Preliminary Plan No. 120120060, Site Plan No. 820120040, North Bethesda Market II

Date of Staff Report: 2/17/12

PRELIMINARY PLAN RECOMMENDATION AND CONDITIONS

SITE PLAN RECOMMENDATION AND CONDITIONS

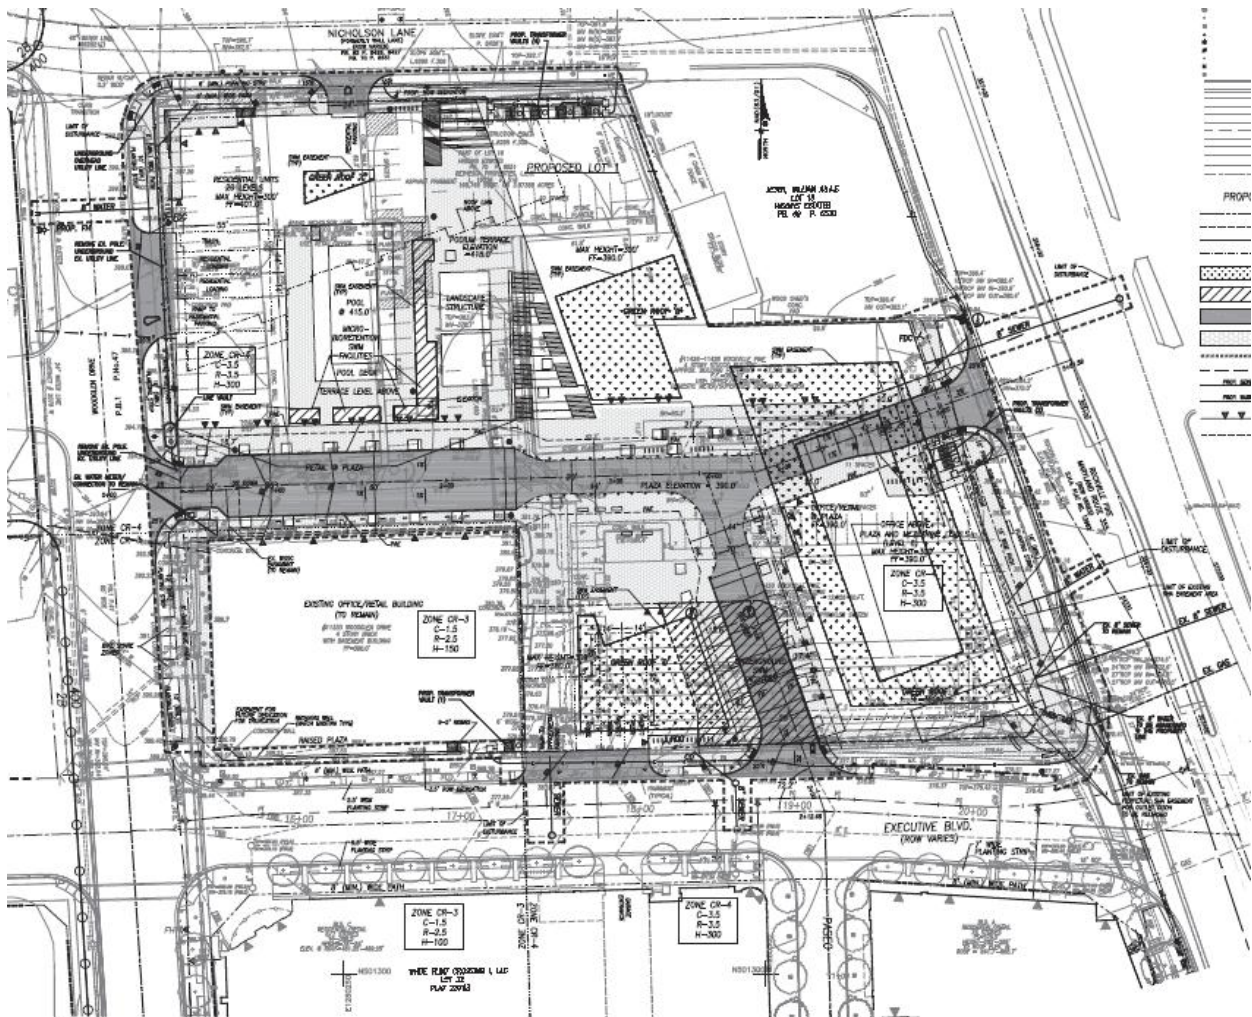
- a. Transit Proximity
 - Submit revised calculation based on Metro Station portal on east side of Rockville Pike.
 - b. Neighborhood Services
 - Revise table to show only 10 different basic services as defined by the approved incentive density guidelines.

- b. Two public benefits, Streetscape and Dwelling Unit Mix, originally approved by the sketch plan have been removed because the details of the site plan show that the criteria for these

Preliminary Plan

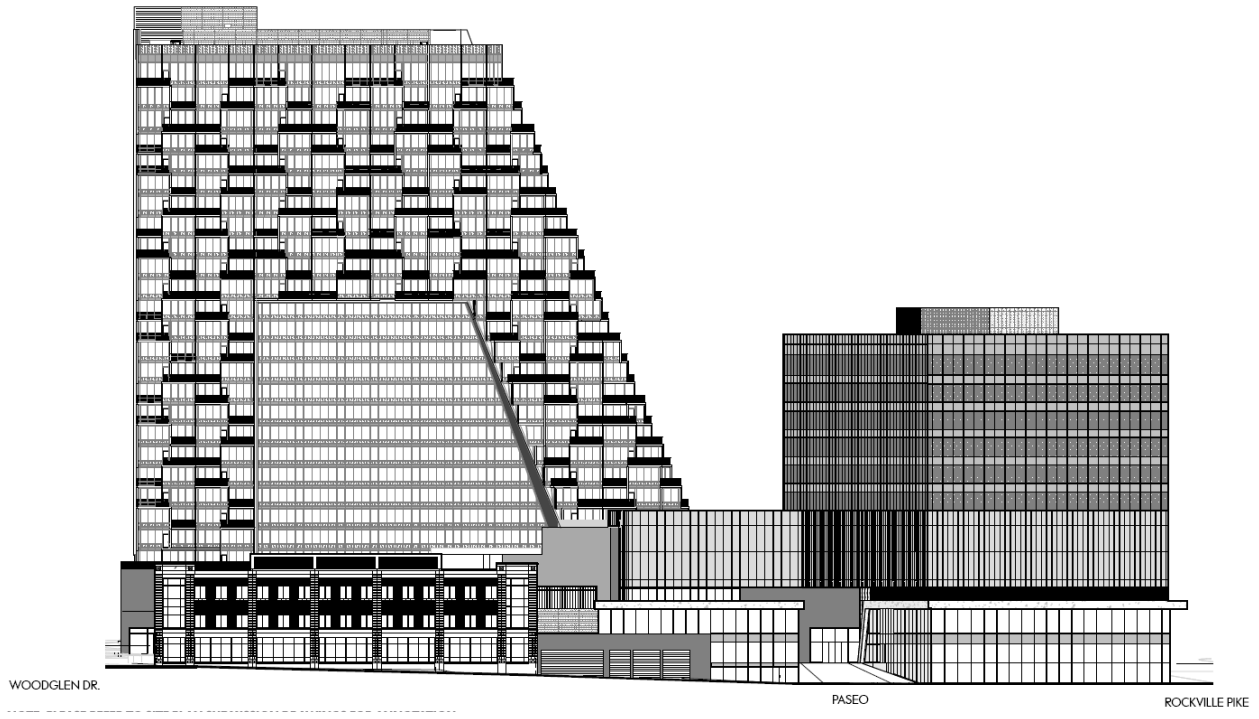
2. The Applicant must dedicate, and the record plat must reflect, the sector-plan recommended 150-foot right-of-way (75 feet from centerline) and the sector-plan recommended 12-foot reservation (an additional 6 feet from each right-of-way line) for a total of 81 feet from centerline for Rockville Pike (MD 355) as shown on the Preliminary Plan.

3. The Applicant must dedicate, and the record plat must reflect, the sector-plan recommended 90-foot right-of-way (45 feet from centerline) for Nicholson Lane as shown on the Preliminary Plan.

4. The Applicant must dedicate, and the record plat must reflect, the sector-plan recommended 80-foot right-of-way (40 feet from centerline) for Executive Boulevard as shown on the Preliminary Plan. Dedication for truncation at the intersection of Executive Boulevard and Woodglen Drive will occur at the time of future redevelopment of the existing commercial building that is being retained.
